H TECHNICAL BULLETIN

HAS 400 TRUCK AIR SUSPENSION MAIN SUPPORT MEMBER IMPROVEMENT

No: 49441-128 (TRUCK AUS-004)
Subject: *Product Update*
Date: September 1996 **Revision:** A

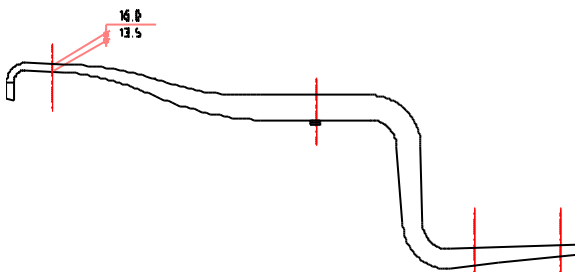
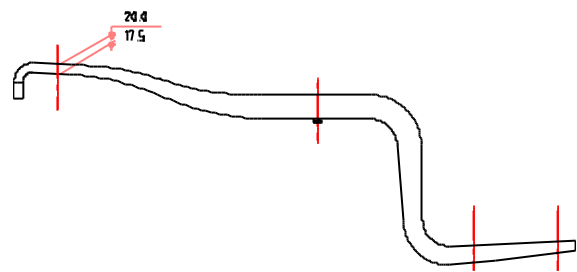
As part of our continuous product improvement program, Hendrickson has increased the thickness of the Main Support Member on the HAS 400 air suspension, at frame hanger end. The Main Support Main has increased from 13.5/16.0mm to 17.5/20.0mm as shown above.

This change will not effect the installation of the suspension in any way. In service, the two Main Support Members are interchangeable.

This improvement is intended to increase Main Support Member durability.
